Access Compliance Report

Public Rights-of-Way

(Curb Ramps)

Intersection ID: 9328	Main Street: PLAZA_LN	Cross Street: THE_PLAZA	Location: W
ADA ID: CA77C4079730	Ramp Type: PerpDiag	Initial Pass/Fail: Fail	Overall Compliance: No
			Severity Score: 26.25

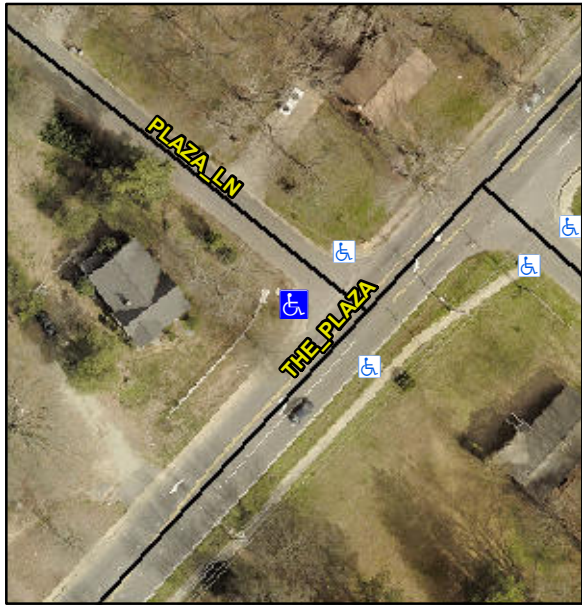
Codes/Mitigation Info/Possible Solution			Field Measurements/Component Compliance					
	Possible Solutions:		Compliance	Description	Data	Compliance	Description	Data
	Remove & Replace Curb Ramp With Two New Directional Ramps or Equivalent.		N/A	Ramp Length (in)	63.0	No	Ramp Slope (%)	12.1
			Yes	Ramp Width (in)	48.0	No	Ramp XSlope (%)	3.0
			N/A	Flare Type LT	N/A	N/A	Flare Type RT	N/A
			N/A	Flare Slope LT (%)	N/A	N/A	Flare Slope RT (%)	N/A
			N/A	Flare Traversable LT?	N/A	N/A	Flare Traversable RT?	N/A
			N/A	Landing Length (in)	N/A	N/A	DWS Provided?	N/A
			N/A	Landing Width (in)	N/A	N/A	DWS Contrast?	N/A
			N/A	Landing Slope (%)	N/A	N/A	DWS Length (in)	N/A
			N/A	Landing X Slope (%)	N/A	N/A	DWS Full Width?	N/A
Surveyor Notes:			N/A	Landing Curb? (Y/N)	N/A	N/A	DWS Offset (in)	N/A
N/A			N/A	Shared Landing?	N/A			
PROW/ADA:			N/A	Gutter Ponding?	Yes	N/A	Gutter Slope (%)	N/A
Not Found, R304.2.2, R304.5.3			N/A	Gutter Lip Ht (in)	1.0	N/A	Gutter X Slope (%)	N/A
